Proposal: Erection of 53 dwellings and associated works | Land at, Barnsley Road, Denby Dale, Huddersfield, HD8 8TS

Objection – impacts on unmapped ancient woodland and access

Effects on Tanner Wood and Wildlife Habitats

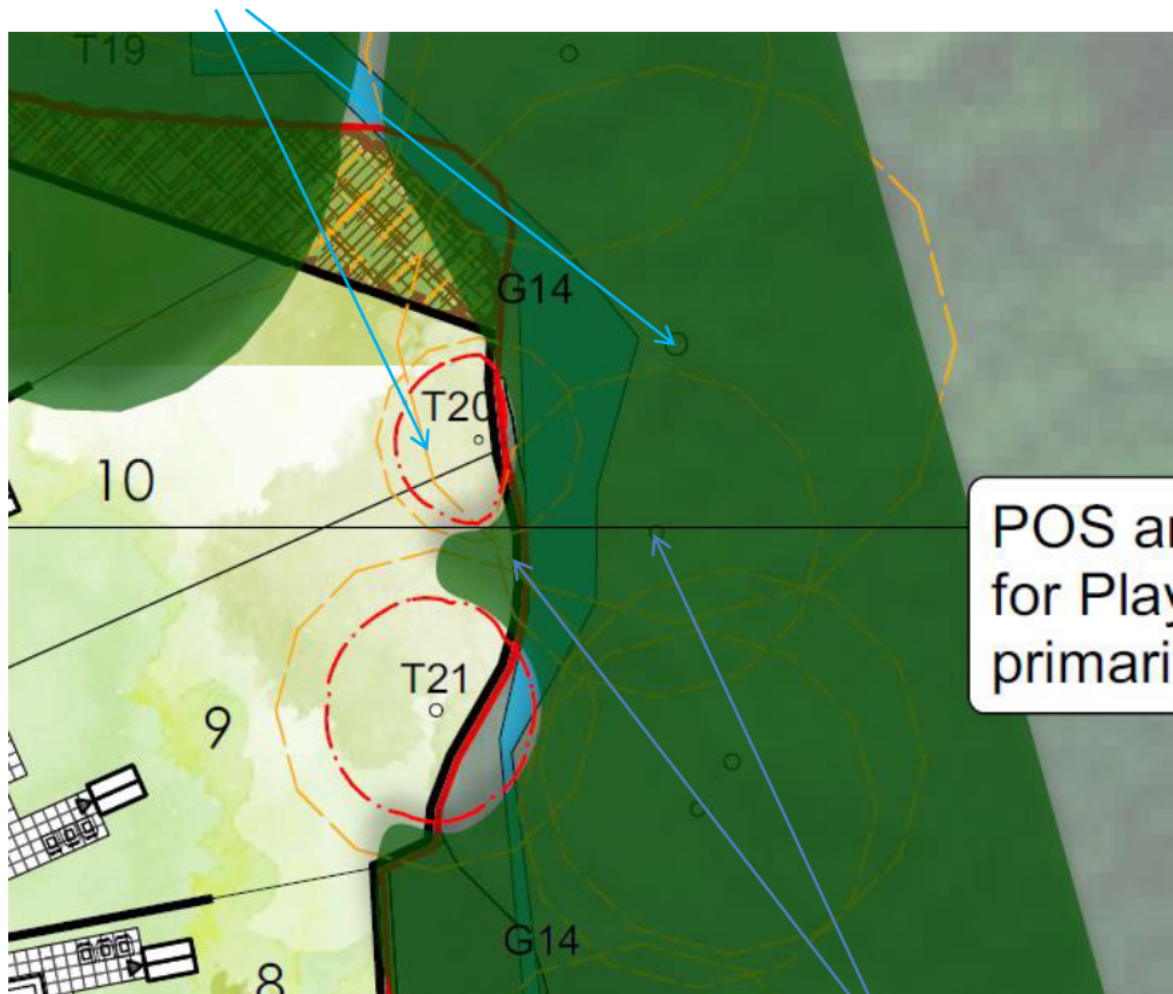
This advice seems to have been largely ignored by the proposed development layout, as can be seen in this table of the RPA threats for each of the affected Tanner Wood trees:

Tree	Location	Threats to Tree RPA's
T19 Oak	Adjacent to Plots 10, 11, 12	Ground level increased by 3-5 metres, New retaining wall 3-5 metres high. Underneath garden of plots 10, 11, & 12.
T18 Oak	Adjacent to Plot 12	Ground level increased by 5 metres, New retaining wall 5 metres high. Underneath retaining wall.
T17 Oak	Adjacent to Plot 13	Ground level increased by 5.5 metres, Foundations of new retaining wall 5.5 metres high at edge of RPA.
G14 Oak 'A'	Rear of Plot 9	Ground level increased by 3 metres, New retaining wall 3 metres high. Underneath garden of plot 9.
G14 Oak 'B'	Rear of Plot 10	Ground level increased by 3 metres, New retaining wall 3 metres high. Underneath garden of plot 9/10.
T22 Sycamore	Adjacent to Plot 7	Ground level increased by 3 metres, New retaining wall 3 metres high. Underneath retaining wall.
T23 Hawthorn	Adjacent to Plot 7	Ground level increased by 3 metres, New retaining wall 3 metres high. Underneath retaining wall.

T25 Horse Chestnut	Opposite Plot 1	Ground level increased by 1.8 metres, New retaining wall 1.8 metres high. Underneath retaining wall, and corner of new road.
G14 Oak 'C'	Rear of Plot 17	New 'Native Shrub spot planting' area (control of digging needed)
T16 Oak	Rear of Plot 15	New 'Native Shrub spot planting' area
G24	Rear of Plots 5, 6	Adjacent Ground level increase of 2 metres, and building of retaining wall 2 metres high

To avoid these significant issues, the layout will need to be reviewed and amended, moving the increased ground levels, and retaining wall, away from the RPA's of all of the trees in the table above. This will affect Plots from 7 to 13.

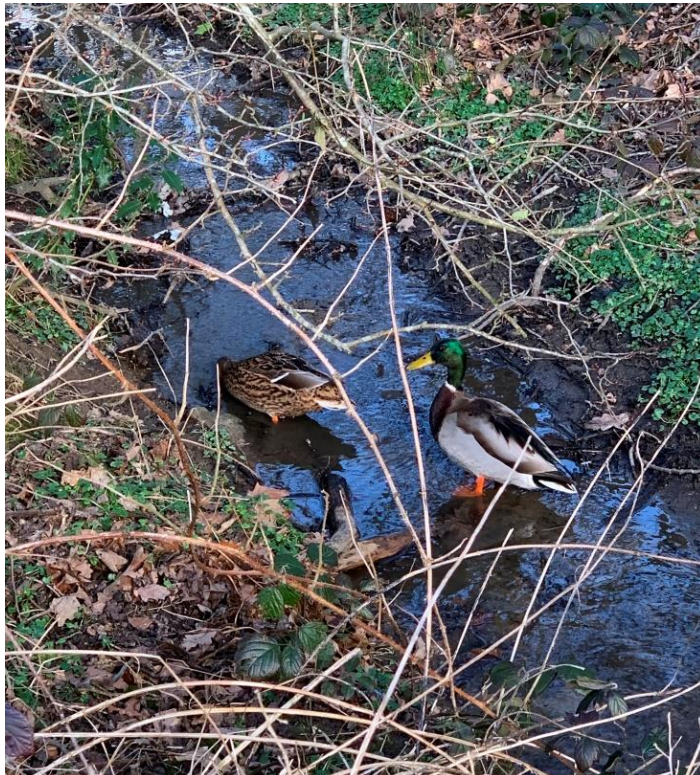
For example, BS5837, Page 8 – Table 1 shows how trees may be categorised both as individuals, and for their Landscape value within a group or woodland. There is also a subcategory for Cultural value. Thus subcategories within Retention value A, are A1, A2, and A3.

AWA consultants have not followed the Standard to this level of detail unfortunately, and had they done so then T19 and T13 for example may have been classified as A2, and therefore A, for being a natural part of the overall woodland.

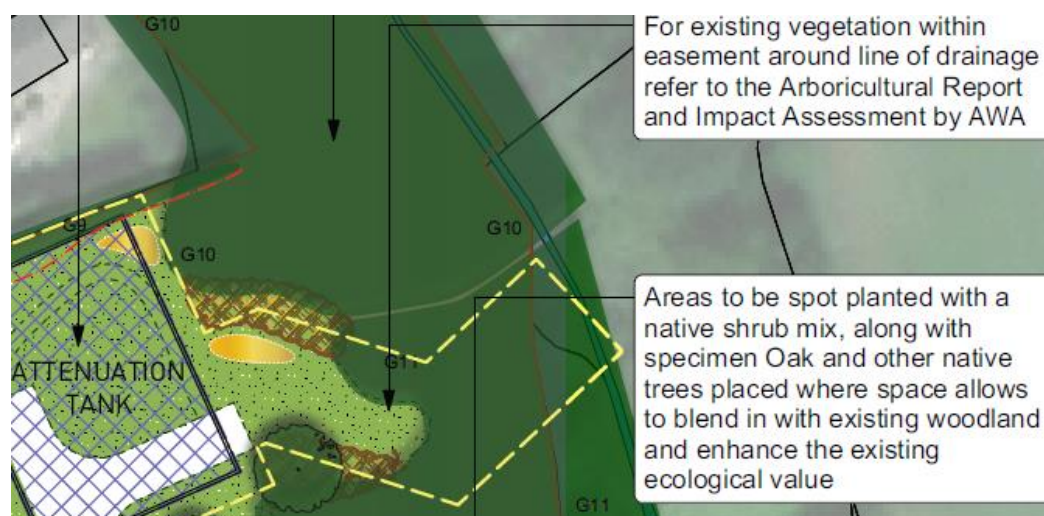
The separation distance from the proposed retaining wall and garden fencing to the watercourse is in some cases less than 1m, and at most under 6m.

It is alongside this watercourse that native woodland plants such as Wood Sorrell, and Lesser Celandine are currently seen, therefore protection of this habitat is a priority.

The risks to the watercourse appear most significant during the construction phase, as the proximity of the retaining wall position to the watercourse, combined with the need to install Tree protection fencing and contaminant prevention silt fencing, whilst allowing space to excavate wall foundations, make it seem inevitable that the watercourse will be contaminated and the banks damaged. Appendix 1 shows an illustration of this.

From the landscape perspective a buffer zone should be allowed for in this part of the development, to protect the watercourse, and flora, from human proximity, and the potential for the unintentional release and spread of invasive plant species from private gardens.

Appendix 1.

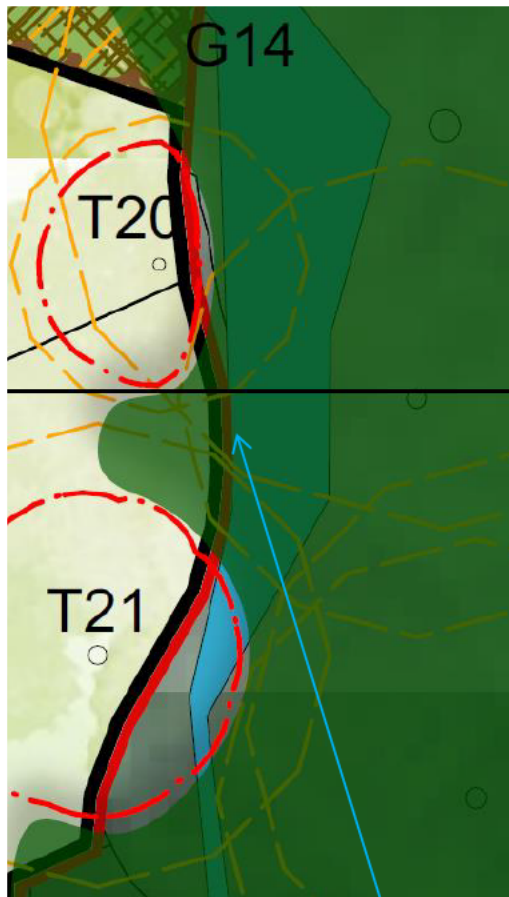
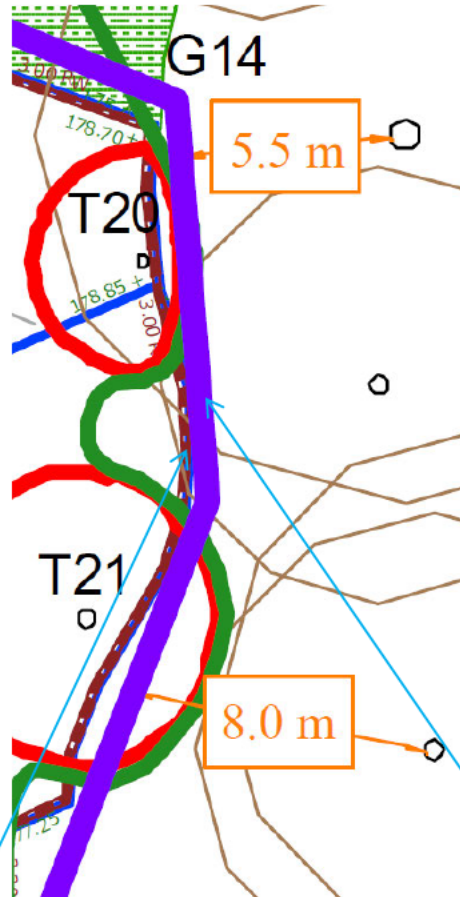
These extracts are from the Site Layout drawing, and the Arboriculture Method Statement:

Watercourse – Hayley Well Beck

Retaining wall

Tree protection fencing
